ROGER L. DONALDSON, AIA P.L.C.
ARCHITECT

FOREST HILLS NATURE CENTER3
PAGE 2 OF 2

Project #24-43

Questions & Answers

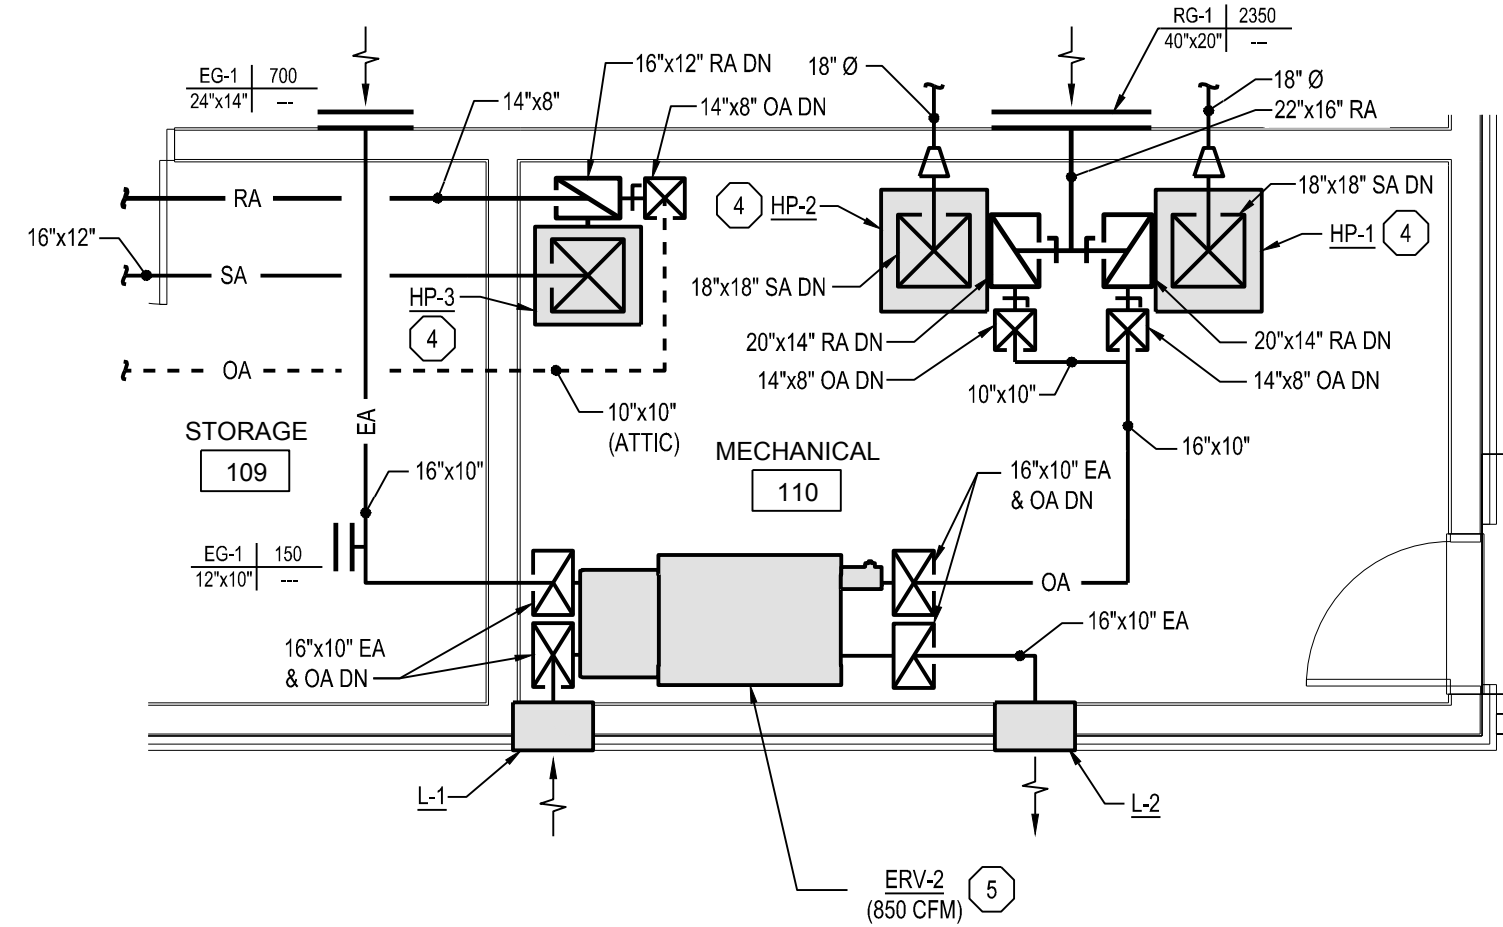
-
55. FrIs the clerestory opening shown on A2.1 West Elevation to be storefront?

Response: Windows to match the fixed windows below, Anderson Series "A" Stationary or equal.

**ENLARGED FLOOR PLAN
 MECHANICAL ROOM
 POWER**

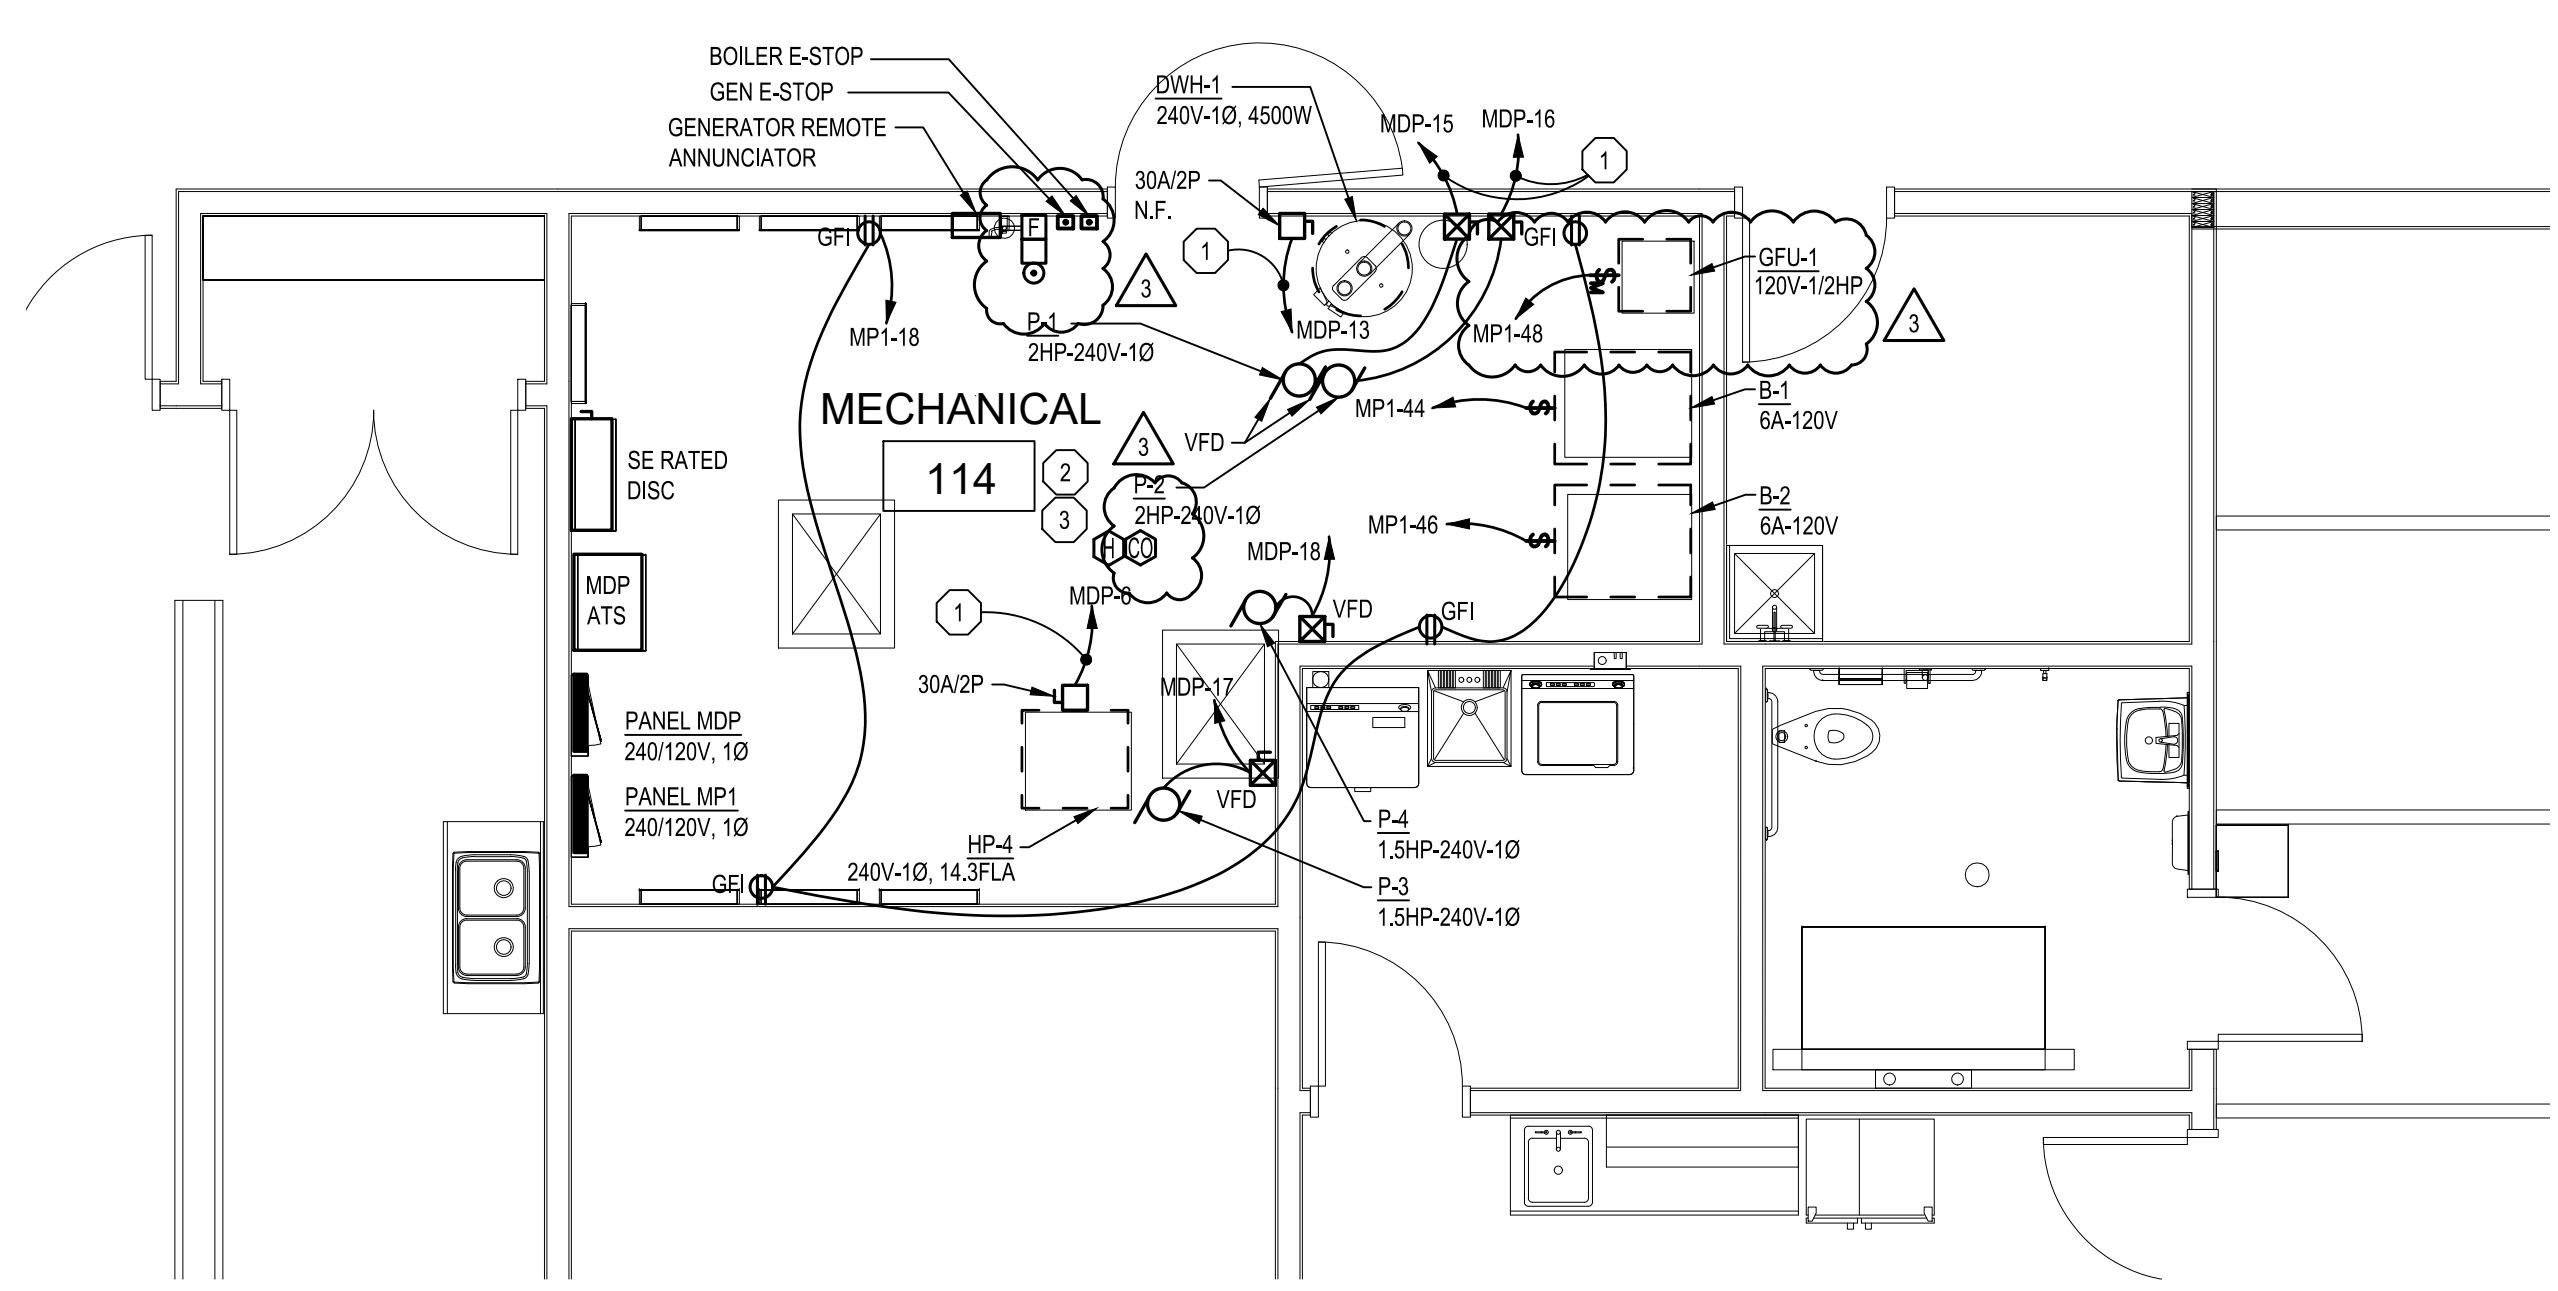
- a. Modified drawings to show circuit designation for mechanical equipment GFU-1.
- b. Modified drawings to show carbon monoxide detector in mechanical room.

- 1 (2) #10, (1) #10 GND, (1) 3/4" CND.
- 2 COORDINATE ATTIC ACCESS WITH CONDUITS/DUCTWORK/PIPING TO AVOID CONFLICTS WITH THE ATTIC ACCESS PANEL.
- 3 CONTRACTOR SHALL PROVIDE APPROVED FIRE STOPPING MATERIALS AT ALL WALL PENETRATIONS OF MECHANICAL ROOMS.
